SUBDIVISION REPORT - CONCEPT/SPECIAL USE

▶ **FILE #:** 5-SA-26-C **AGENDA ITEM #:** 9
5-D-26-SU **AGENDA DATE:** 5/14/2026

▶ **SUBDIVISION:** RESIDENTIAL DEVELOPMENT
▶ **APPLICANT/DEVELOPER:** KNOXVILLE HABITAT FOR HUMANITY
OWNER(S): Knoxville Habitat for Humanity

▶ **PROPOSED USE:** Single-family attached subdivision

CONCEPT PLAN

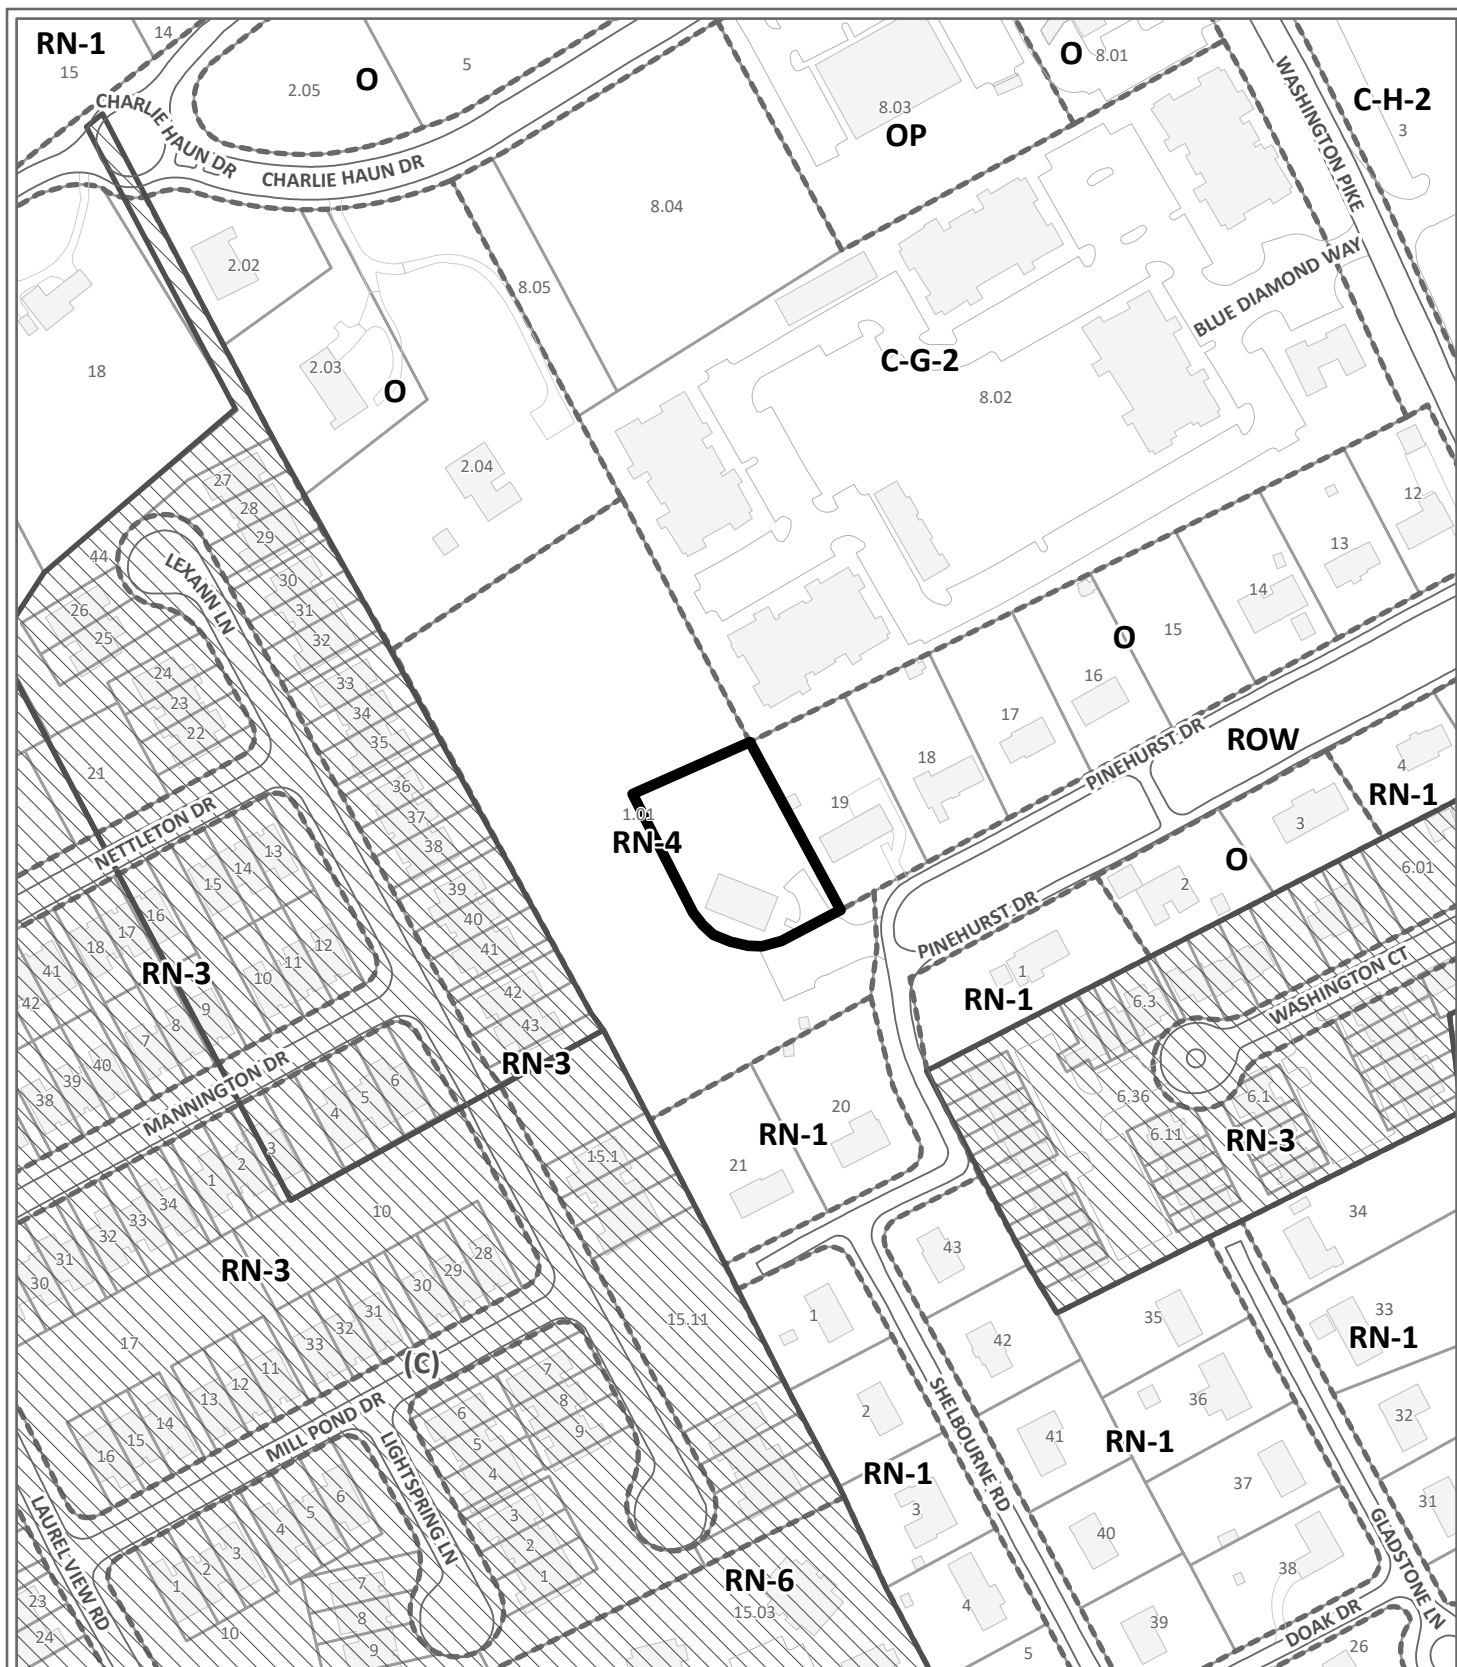
- ▶ **Approve the concept plan application for 22 lots for single-family attached dwellings and one lot for the existing church, subject to 9 conditions.**

6. Installing a fence along the northern property boundary, as shown on the landscape plan, or providing a Type B landscape screen (Exhibit B) at that location.

7. Recording an easement to access the mail kiosk if installed on the church lot, as shown on the site plan, and showing that on the final plat. If the easement cannot be secured, the mail kiosks may be provided in an alternative location, subject to review and approval by the Engineering Department during the design plan phase.

8. During the design plan phase, submitting a revised roadway profile that includes an AASHTO compliant vertical curve at the intersection of Road A and Pinehurst Drive for review and approval by the City of Knoxville Engineering Department.

9. During the design plan phase, obtaining necessary permission from KUB for the proposed access and common area with the KUB transmission line easement.
